**AGENDA**  
**City of Monona Plan Commission**  
**Monona Public Library - Municipal Room**  
**1000 Nichols Road, Monona, WI**  
**Monday June 27, 2016**  
**7:00p.m.**

**PLAN COMMISSION STAFF REPORT  
CITY OF MONONA**

Enclosed is the revised existing, site, and grading/erosion control plan set for The Kilgust Drive Building Addition for Wiedenbeck, Inc. The plans have been revised to address comments contained in your letter dated June 7<sup>th</sup>. The responses to comments are as follows:

**2451 KILGUST ROAD BUILDING ADDITION**  
 DRAINAGE BASIN MAP  
 SHEET: C-5  
 DATED: JUNE 17, 2016

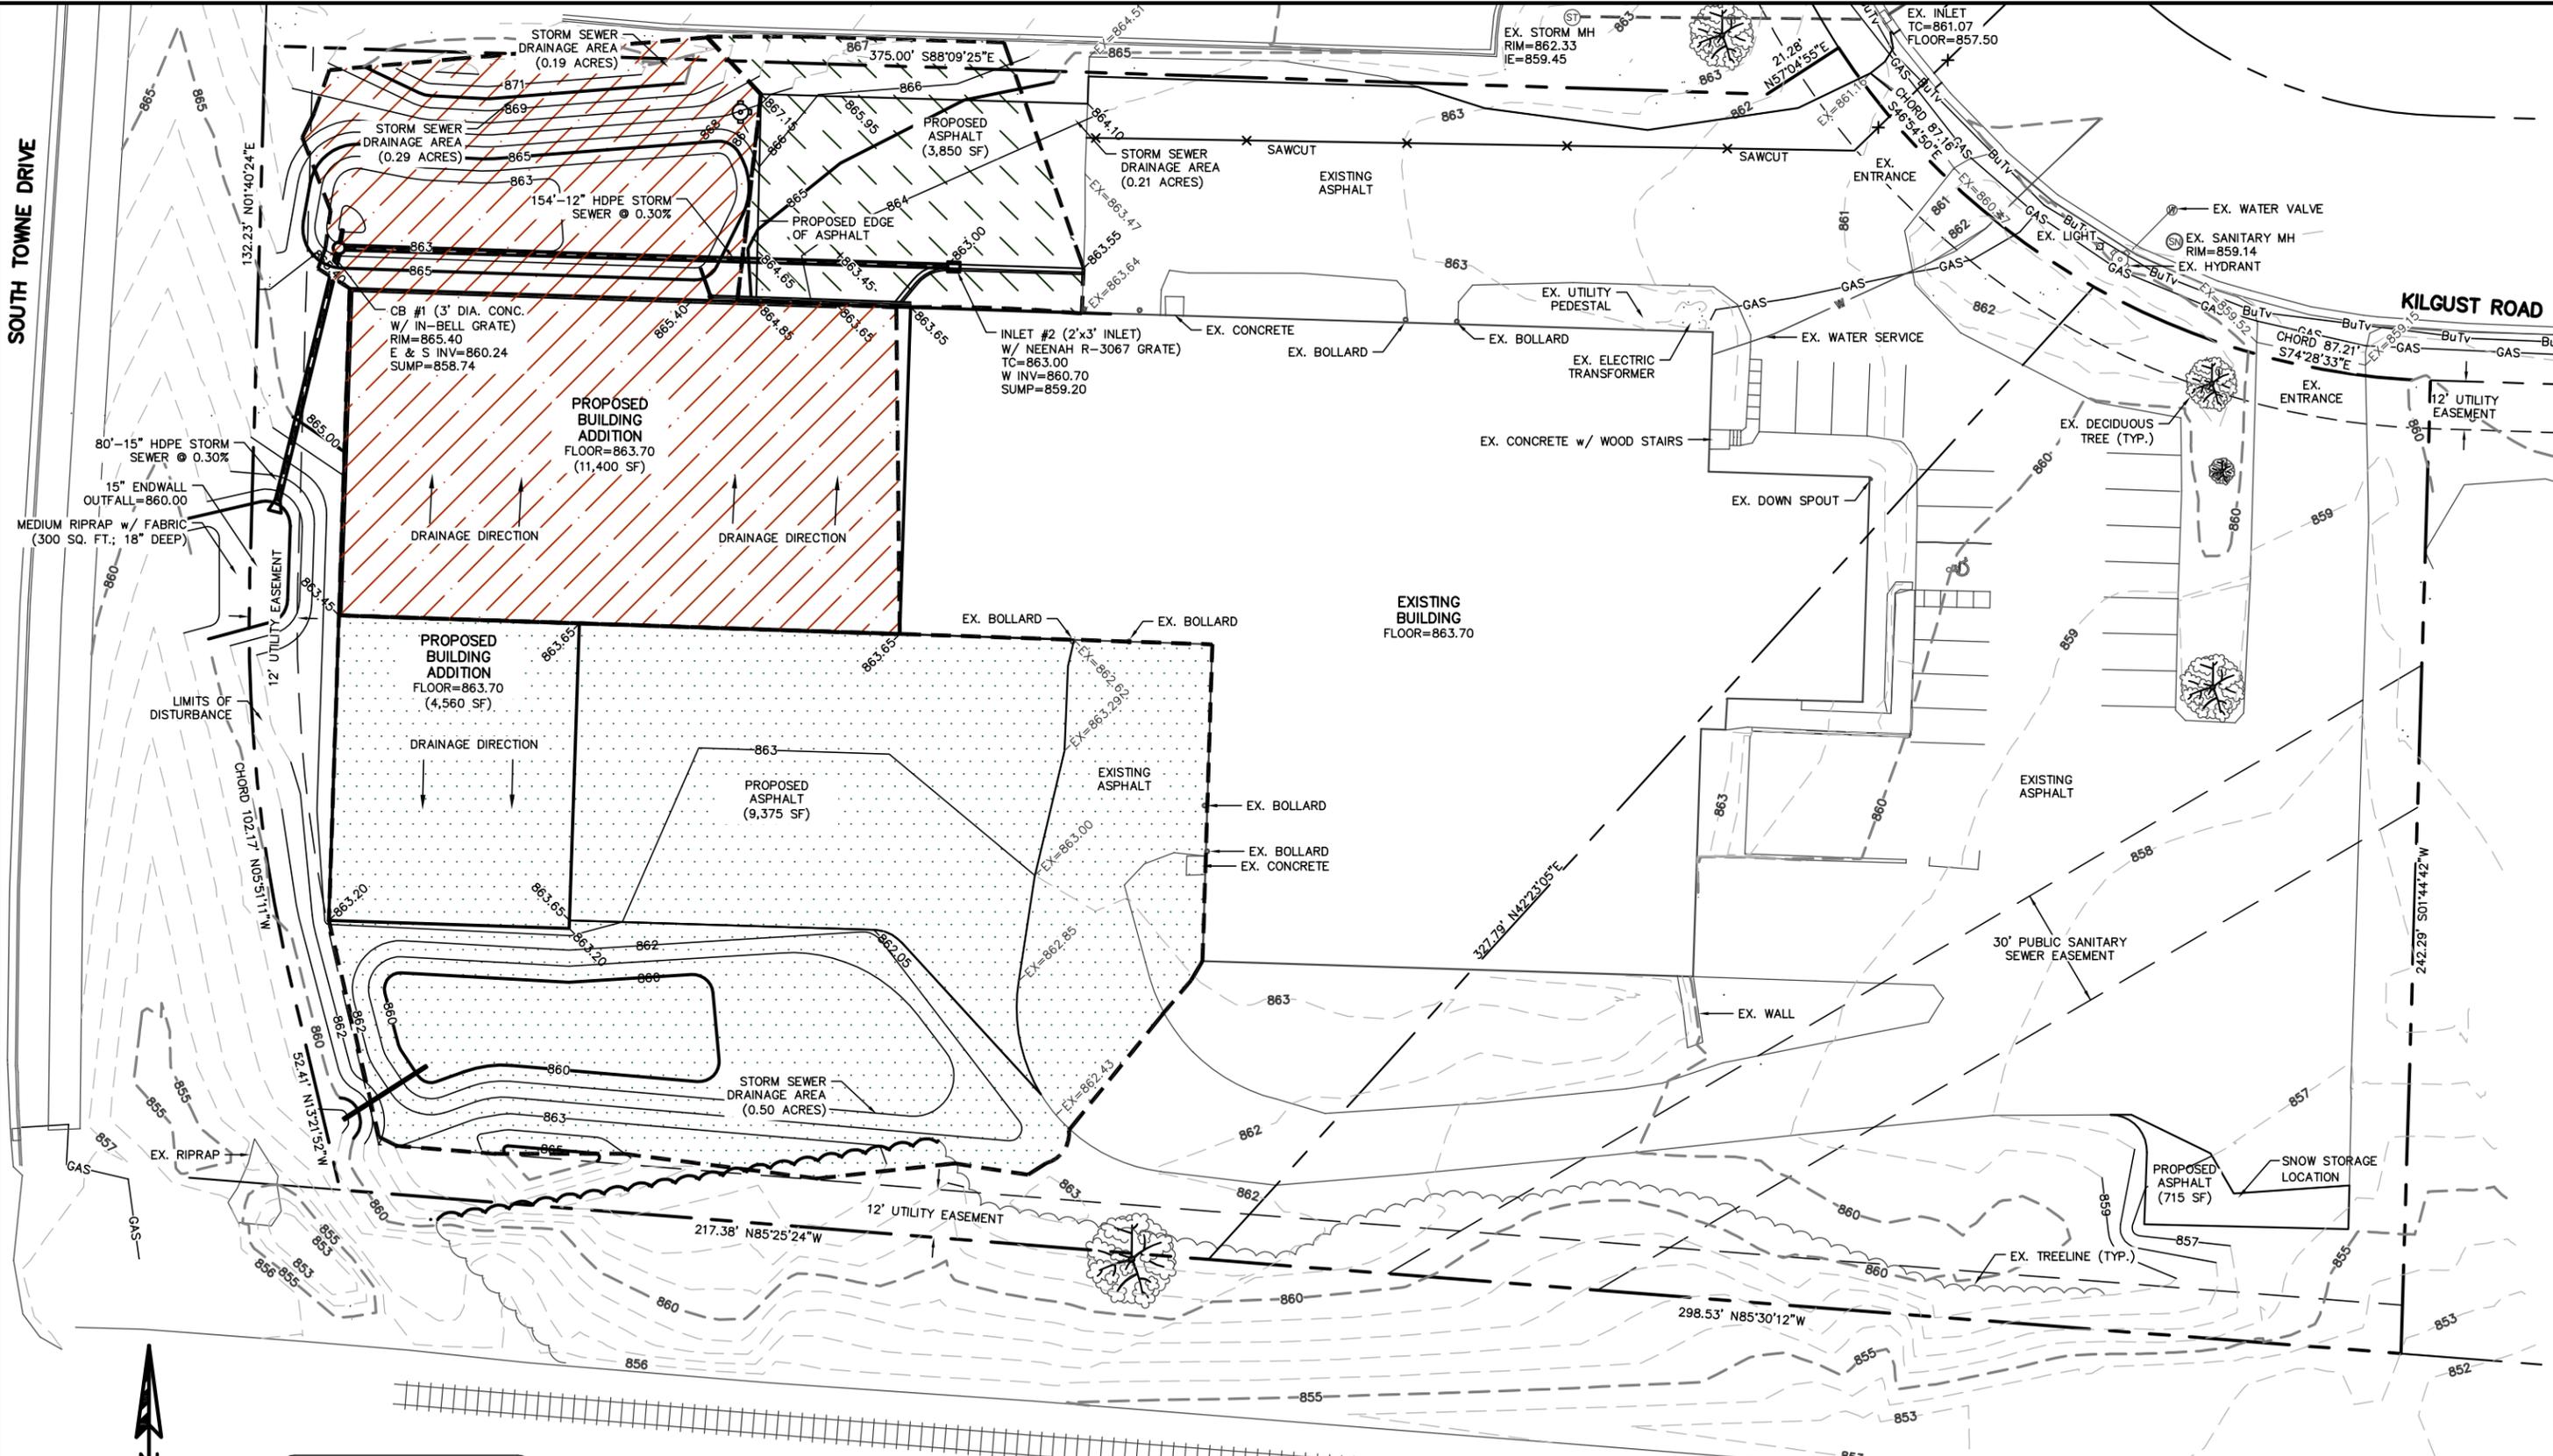
- *The application should be revised to include an exhibit delineating the storm sewer drainage areas.*  
**The Drainage Basin Map is attached.**
- *A stormwater maintenance agreement including provisions for maintenance of the on-site storm sewer pipe, inlet and catch basin needs to be submitted.*  
**The stormwater maintenance agreement is attached.**
- *See “Stormwater Management Application Checklist” for additional comments.*  
**The revised Stormwater Management Application Checklist is attached.**
